Access Compliance Report

Public Rights-of-Way

(Curb Ramps)

Intersection ID: 29374	Main Street: BUCKVALLEY_DR	Cross Street: PLEASANT_DALE_DR	Location: NE
ADA ID: 314E29464BB3	Ramp Type: PerpDiag	Initial Pass/Fail: Fail	Overall Compliance: No
Severity Score: 25			
Codes/Mitigation Info/Possible Solution		Field Measurements/Component Compliance

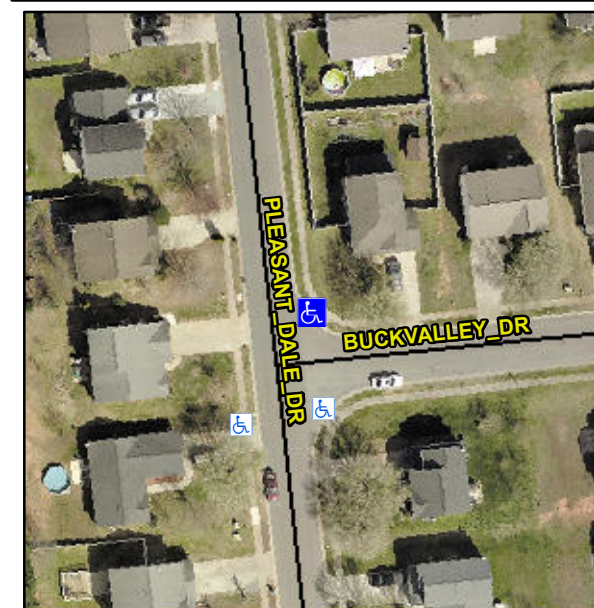
Not Found, R304.5.3

Compliance	Description	Data	Compliance	Description	Data
N/A	Ramp Length (in)	47.0	Yes	Ramp Slope (%)	7.5
Yes	Ramp Width (in)	48.0	No	Ramp XSlope (%)	10.0
N/A	Flare Type LT	N/A	N/A	Flare Type RT	N/A
N/A	Flare Slope LT (%)	N/A	N/A	Flare Slope RT (%)	N/A
N/A	Flare Traversable LT?	N/A	N/A	Flare Traversable RT?	N/A
N/A	Landing Length (in)	N/A	N/A	DWS Provided?	N/A
N/A	Landing Width (in)	N/A	N/A	DWS Contrast?	N/A
N/A	Landing Slope (%)	N/A	N/A	DWS Length (in)	N/A
N/A	Landing X Slope (%)	N/A	N/A	DWS Full Width?	N/A
N/A	Landing Curb? (Y/N)	N/A	N/A	DWS Offset (in)	N/A
N/A	Shared Landing?	N/A			
N/A	Gutter Ponding?	N/A	N/A	Gutter Slope (%)	N/A
N/A	Gutter Lip Ht (in)	N/A	N/A	Gutter X Slope (%)	N/A
N/A	Painted X Walk1?	No	N/A	Painted X Walk2?	No
	X Walk 1 Direction	To W		X Walk 2 Direction	To S
N/A	X Walk 1 Width (in)	N/A	N/A	X Walk 2 Width (in)	N/A
	X Walk 1 Slope (%)	7.5		X Walk 2 Slope (%)	4.3
	X Walk 1 X Slope (%)	5.8		X Walk 2 X Slope (%)	6.2

Remove & Replace Curb Ramp With Two New Directional Ramps or Equivalent.
